ORDINANCE A

AN ORDINANCE AMENDING SECTION 3.11 OF THE CHAPEL HILL LAND USE MANAGEMENT ORDINANCE TO UPDATE STANDARDS FOR BUILDING MASSING AND PERMEABILITY IN THE BLUE HILL DISTRICT (2020-02-19/O-1)

Section 3.11.2.3 Walkable Residential (WR-3 and WR-7) Subsection 3. Mass is hereby revised to read as follows:

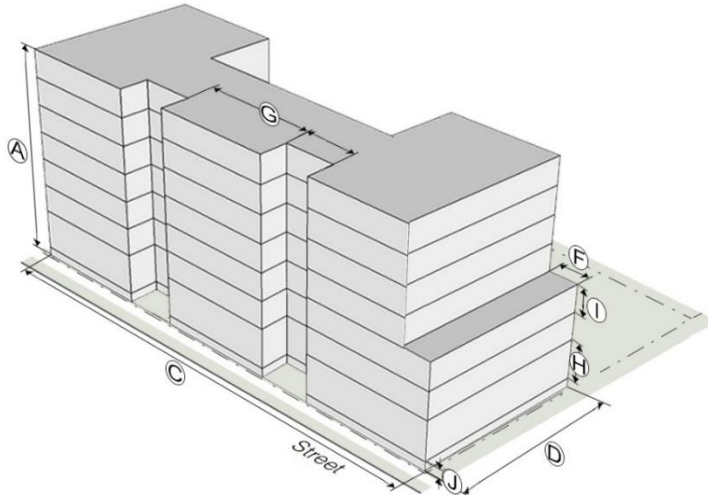
[The diagram above is revised so that labels correspond with items A, C, D, F, G, H, I and J in the associated table, as revised (note that no labels are provided for B and E)]

Building Height				
Ⓐ	Building height (max)			
	- WR-7		7 stories, not to exceed 90'	
	- WR-3		3 stories, not to exceed 45'	
Ⓑ	Building height for principal structures (min)		2 stories*	
Building Footprint and Aggregation				
	Building Configuration	Width (max) Ⓒ	Depth (max) Ⓓ	Separation (min)**
	WR-7, Wrapped Parking			
	- Main Building	330'	200'	30'
	- Secondary Wing	75'	100'	
	WR-7, Wider and Shallower			
	- Main Building	330'	120'	30'
	- Secondary Wing	75'	100'	
	WR-7, Narrower and Deeper			
	- Main Building	275'	210'	30'
	- Secondary Wing	75'	100'	
	WR-3, All Buildings			
	- Main Building	220'	130'	20'
	- Secondary Wing	75'	100'	
	Structured Parking	230'	180'	30'

Section 3.11.2.4. Walkable Mixed Use (WX-5 and WX-7), Subsection 3. Mass is hereby revised to read as follows:

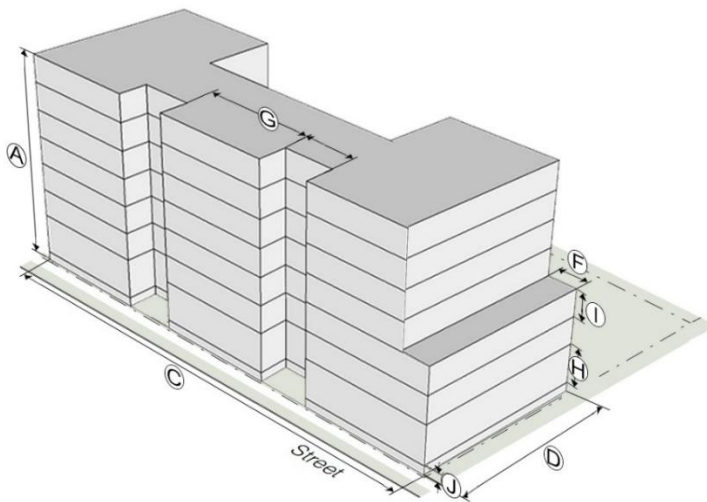
[The diagram above is revised so that labels correspond with items A, C, D, F, G, H, I and J in the associated table, as revised (note that no labels are provided for B and E)]

Building Height				
Ⓐ	Building height (max)			
	- WX-7	7 stories, not to exceed 90'		
	- WX-5	5 stories, not to exceed 60'		
Ⓑ	Building height for principal structures (min)	2 stories*		
Building Footprint and Aggregation				
	<u>Building Configuration</u>	<u>Width (max) Ⓒ</u>	<u>Depth (max) Ⓓ</u>	<u>Separation (min)**</u>
	<u>WR-7, Wrapped Parking</u>

1. Maximum Building Dimensions

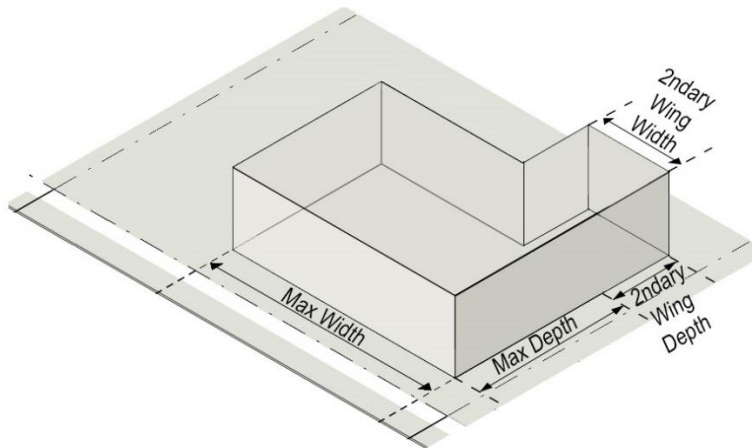
- a. Maximum building width and secondary wing width are measured parallel to the primary frontage for each site.**
- b. Maximum building depth and secondary wing depth are measured perpendicular to the primary frontage for each site, and apply to side facades. A building and wing must adjoin portions of the public realm for the full measurement of their depth.**
- c. A secondary wing, if included, shall be appended to the rear of the building to create an extension of the building’s depth. The wing may not be configured to increase the maximum building width. The depth of the wing shall be measured starting at the point where the building footprint exceeds the baseline maximum depth.**
